Site Accessibility Evaluation

Fountain Creek Nature Center

**320 Peppergrass Ln
Fountain, CO 80817**

Accessibility Evaluation

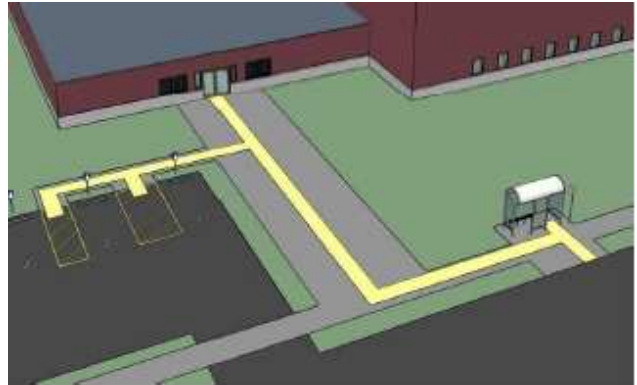
The accessible parking is not located on an accessible route of travel to the accessible building entrance.

**Accessible route from
accessible parking
stalls non-existing.**

Construct accessible path of travel connecting the accessible parking stalls to the circulation path onto the main sidewalk. Ensure surface material is firm, stable and slip resistant.

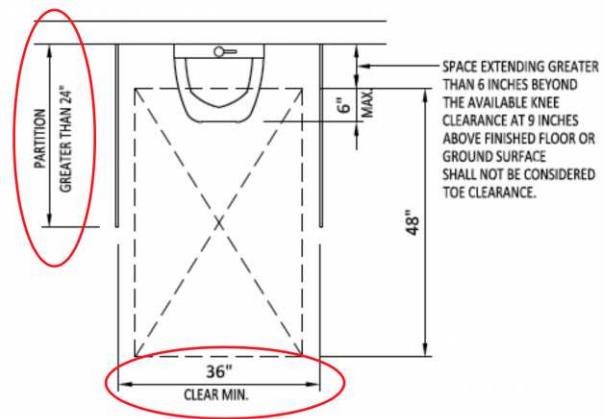
The urinal is confined on three sides (alcove).

Forward approach
measures 31 inches

Due to limited space and placement/protrusion of the changing table into the minimum required cleared floor space for a forward approach, the required 36 inches may not be met. Recommend reconfiguration if and when renovation/remodel is performed to meet compliance.

Finding 297132 Main Photo

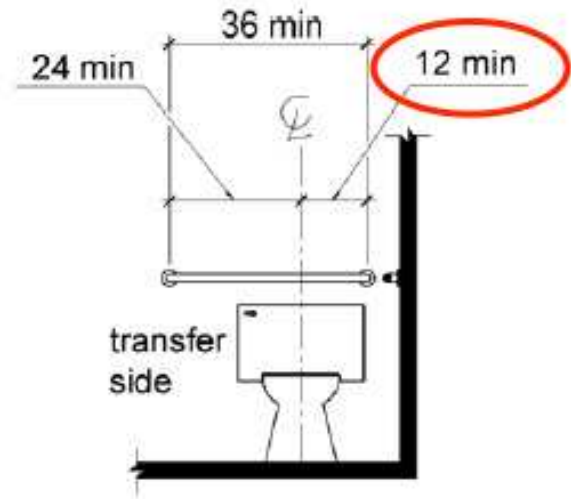
The rear grab bar does not extend adequately past the centerline of the toilet on the wall side.

10.5 inches from
centerline of toilet

Re-position rear grab bar to extend 12 inches minimum on wall side and 24 inches minimum on the transfer side measured from the centerline of the toilet.

Finding 297133 Main Photo

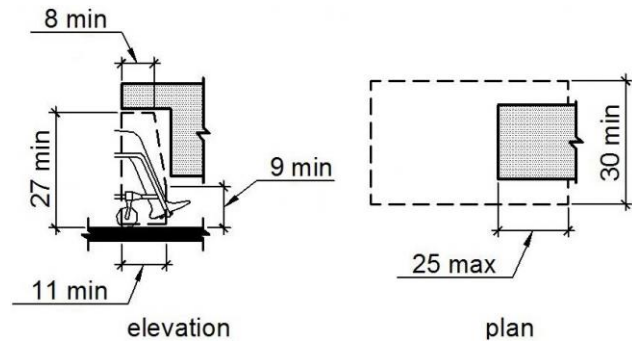
The knee clearance not compliant.

**26.5 inches above
finished floor**

Lower baby changing station to meet the 27 inches minimum required under an element for knee clearance, 28 inches minimum to 34 inches maximum to the top of the table surface and 48 inches maximum height to operable part measured from the finished floor.

Finding 241320 Main Photo

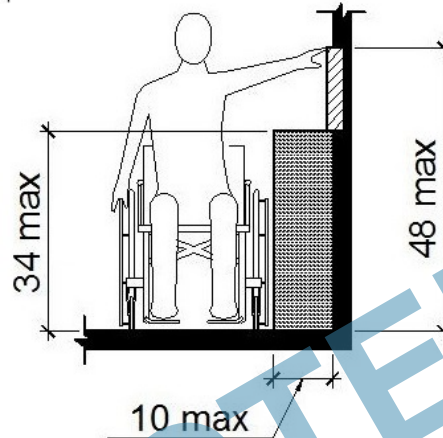
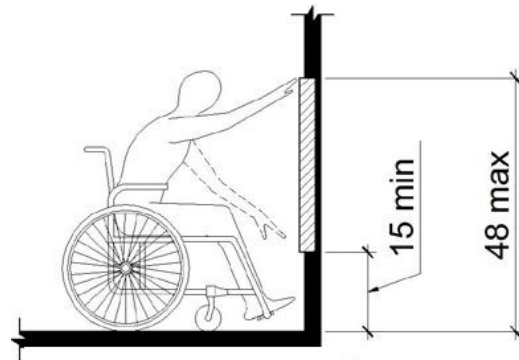
The coat hook is installed greater than 48 inches above the finished floor.

64.5 inches above the floor

Lower coat hook 18 inches minimum or install another coat hook not to exceed a maximum height of 48 inches above finished floor.

Finding 241321 Main Photo

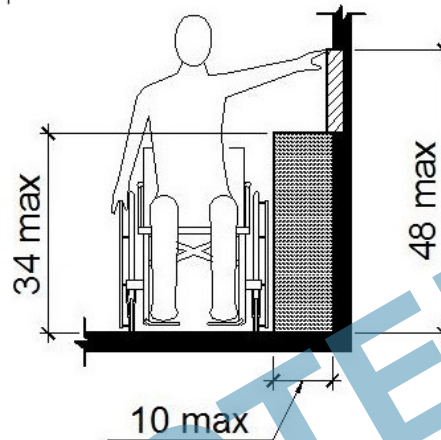
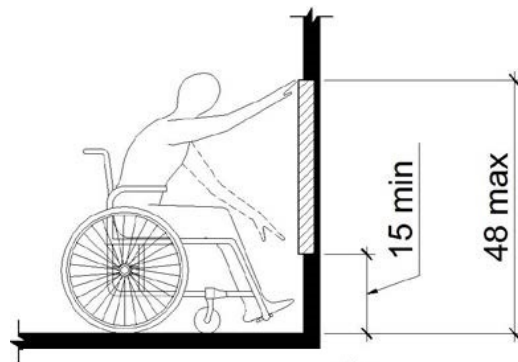
The coat hook is installed greater than 48 inches above the finished floor.

64.5 inches above the floor

Lower coat hook 18 inches minimum or install another coat hook not to exceed a maximum height of 48 inches above finished floor.

Finding 297134 Main Photo

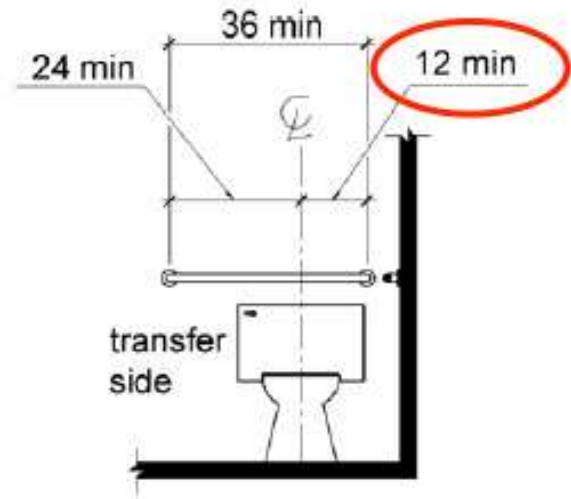
The rear grab bar does not extend adequately past the centerline of the toilet on the wall side.

10.5 inches from
centerline of toilet

Re-position rear grab bar to extend from the centerline of the toilet 12 inches minimum to the wall side and 24 inches minimum to the transfer/open side.

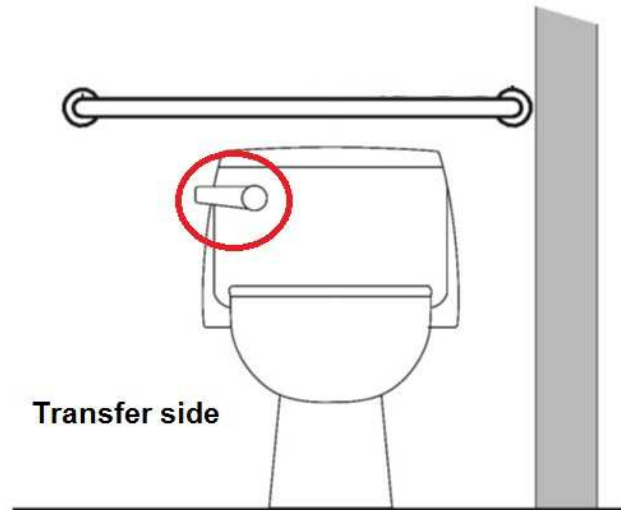
The flush handle is located on the wrong side of the toilet.

Flush handle located
on the closed side

Replace toilet water tank with one that has flush handle on the opposite side (open side of toilet area).
